ARKANSAS NUCLEAR ONE - UNIT NO. 1

AMENDMENT TO FACILITY OPERATING LICENSE

Amendment No. 43  
License No. DPR-51

SAFETY EVALUATION BY THE OFFICE OF NUCLEAR REACTOR REGULATION  
SUPPORTING AMENDMENT NO. 43 TO LICENSE NO. DPR-51  
ARKANSAS POWER AND LIGHT COMPANY  
ARKANSAS NUCLEAR ONE, UNIT NO. 1  
DOCKET NO. 50-313

Figure 2.1-2

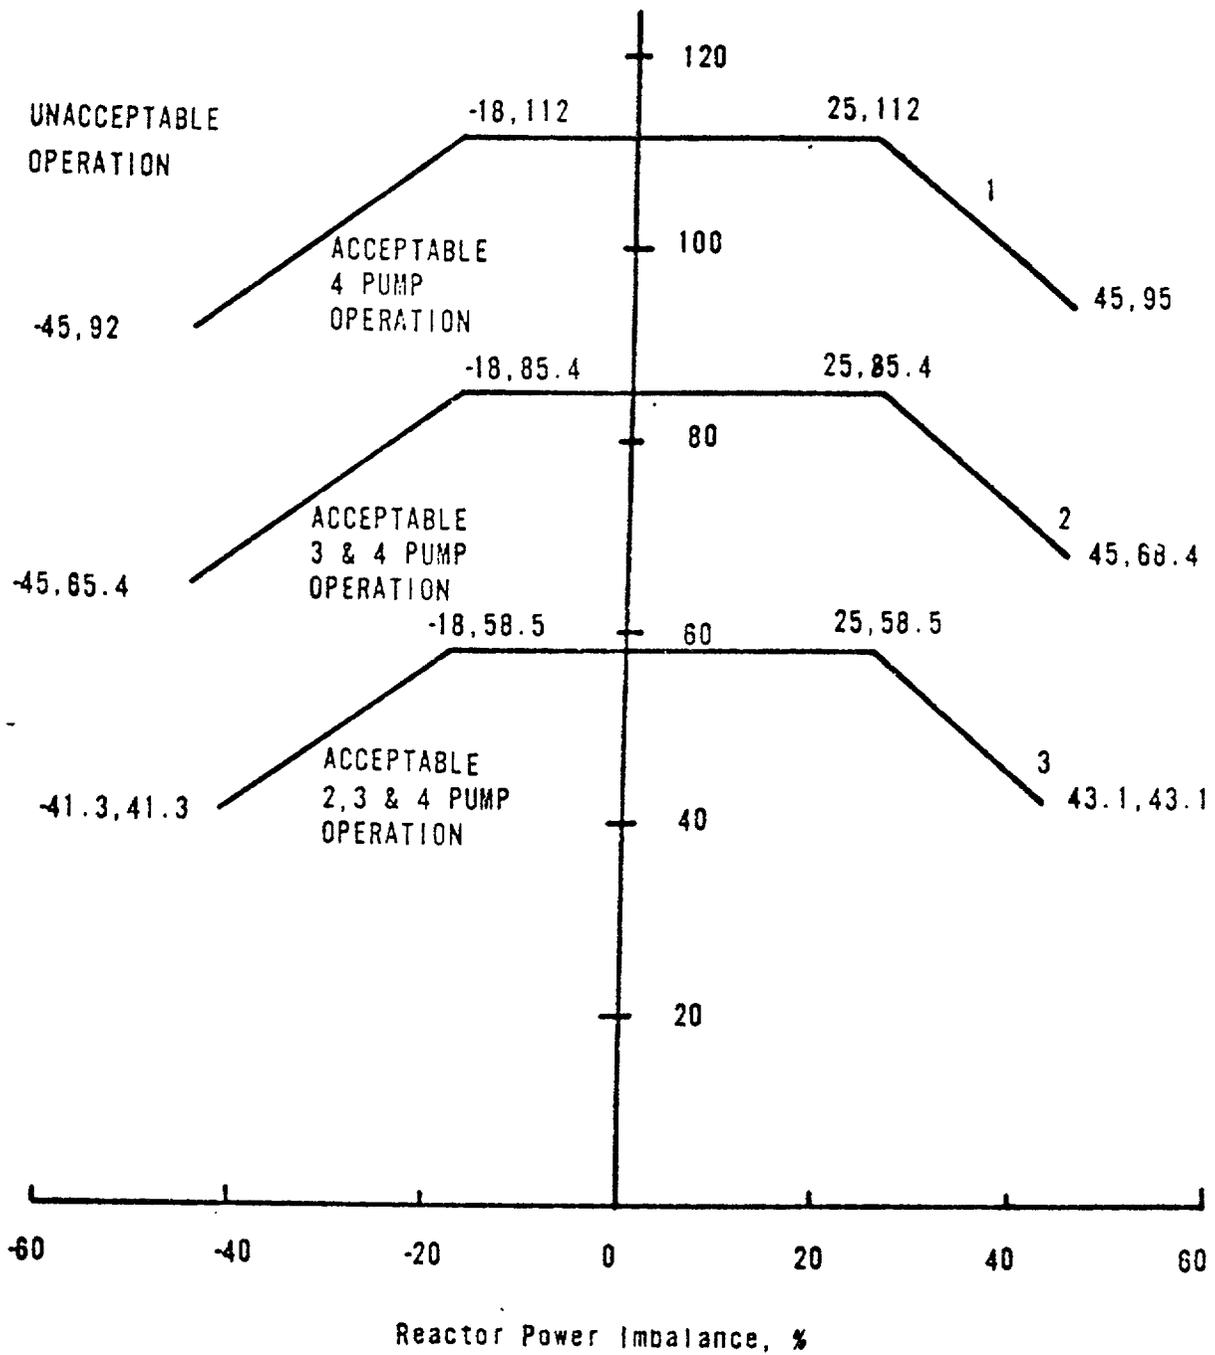
Using a local quality limit of 22 percent at the point of minimum DNBR as a basis for curve 3 of Figure 2.1-3 is a conservative criterion even though the quality at the exit is higher than the quality at the point of minimum DNBR.

For each curve of Figure 2.1-3, a pressure-temperature point above and to the left of the curve would result in a DNBR greater than 1.3 or a local quality at the point of minimum DNBR less than 22 percent for that particular reactor coolant pump situation. Curves 1 & 2 of Figure 2.1-3 are the most restrictive because any pressure/temperature point above and to the left of this curve will be above and to the left of the other curve.

Figure 2.3-2

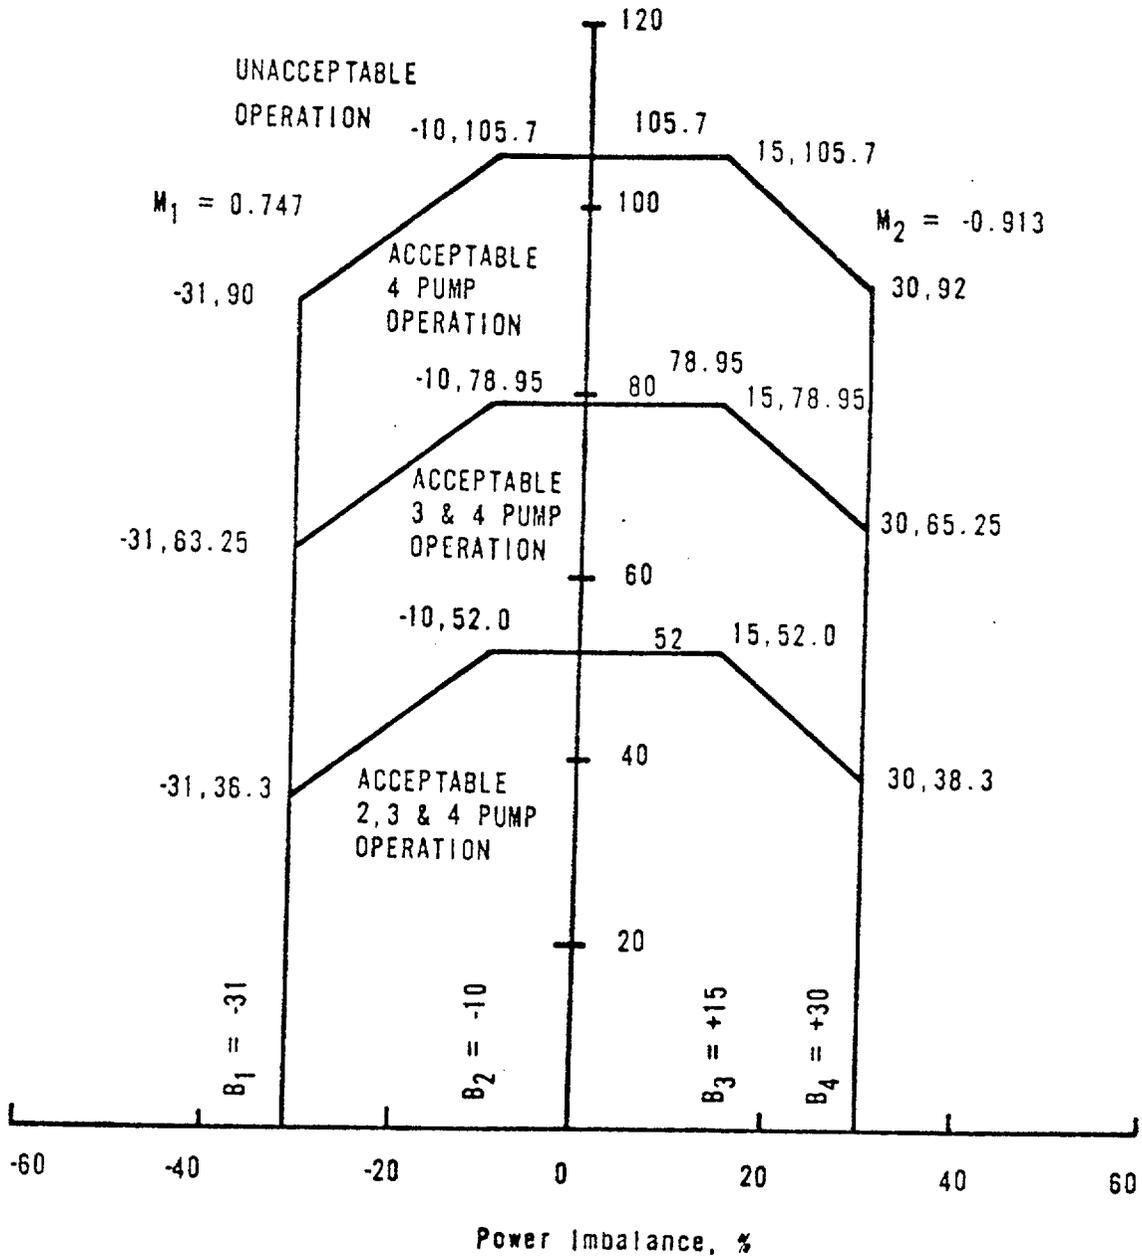
- a. The protection system maximum allowable setpoints (Figure 2.3-2) shall be reduced 2% in power for each 1% tilt.
  - b. The control rod group and APSR withdrawal limits shall be reduced 2% in power for each 1% tilt in excess of 4.92%.

Figure 3.2-1 BORIC ACID ADDITION TANK VOLUME AND CONCENTRATION REQUIREMENTS VS RCS AVERAGE TEMPERATURE

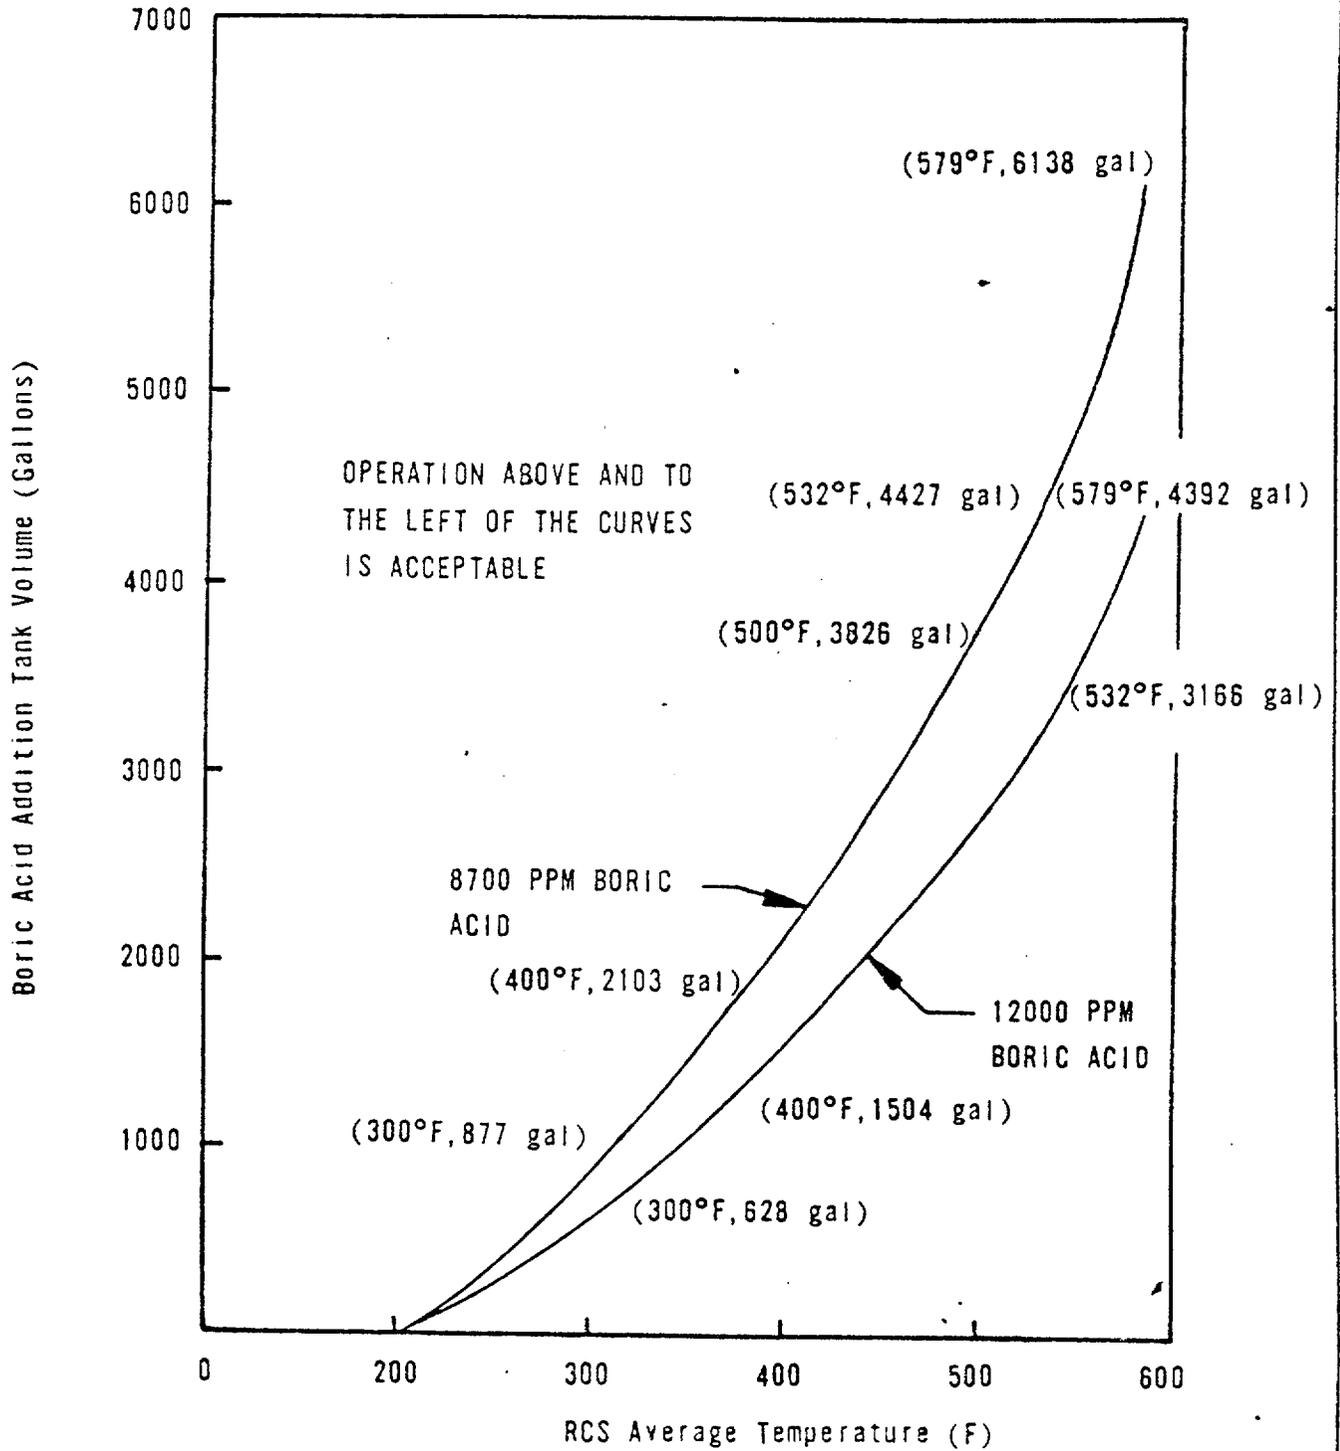
Minimum volumes (including a 10% safety factor) as specified by Figure 3.2 1 for the boric acid addition tank or 35,659 gallons of 2270 ppm boron as boric acid solution in the borated water storage tank (3) will each satisfy this requirement. The specification assures that adequate supplies are available whenever the reactor is heated above 200°F so that a single failure will not prevent boration to a cold condition. The minimum volumes of boric acid solution given include the boron necessary to account for xenon decay.

Figure 3.5.2-1A

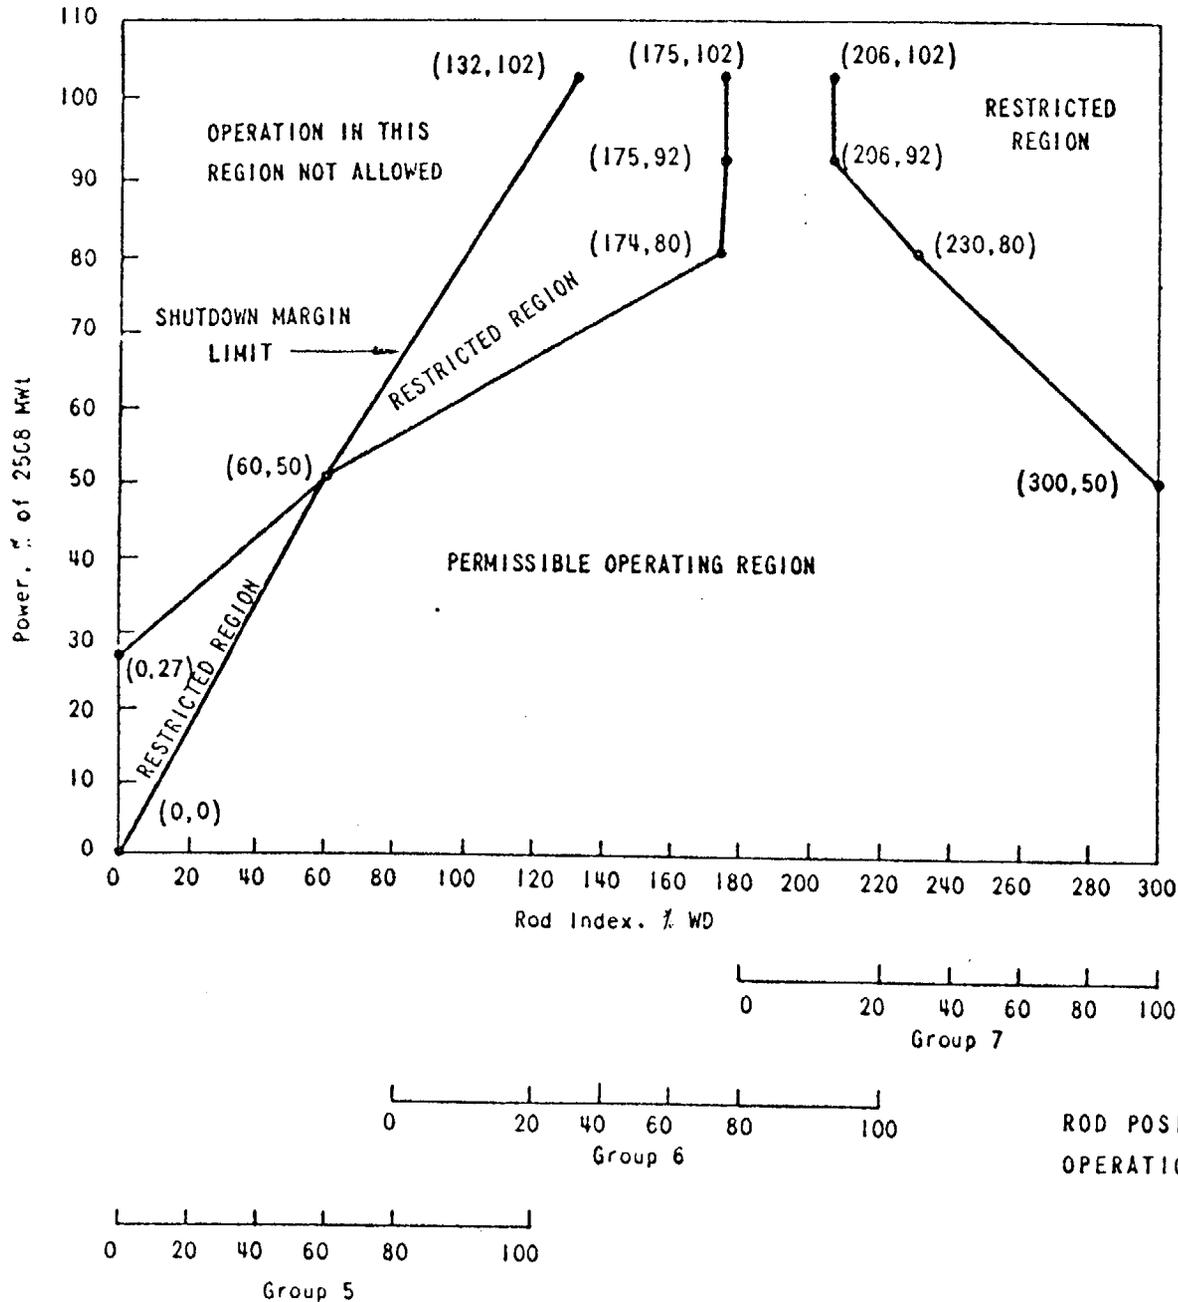
3. Except for physics tests or exercising control rods, a) the control rod withdrawal limits are specified on Figures 3.5.2-1A, 3.5.2-1B and 3.5.2-1C for four pump operation and on Figures 3.5.2-2A, 3.5.2-2B and 3.5.2-2C for three or two pump operation and b) the axial power shaping control rod withdrawal limits are specified on Figures 3.5.2-4A, 3.5.2-4B and 3.5.2-4C. If any of these control rod position limits are exceeded, corrective measures shall be taken immediately to achieve an acceptable control rod position. Acceptable control rod positions shall be attained within four hours.
4. Except for physics tests, power shall not be increased above the power level cutoff (see Figures 3.5.2-1) unless the xenon reactivity is within 10 percent of the equilibrium value for operation at rated power and asymptotically approaching stability.
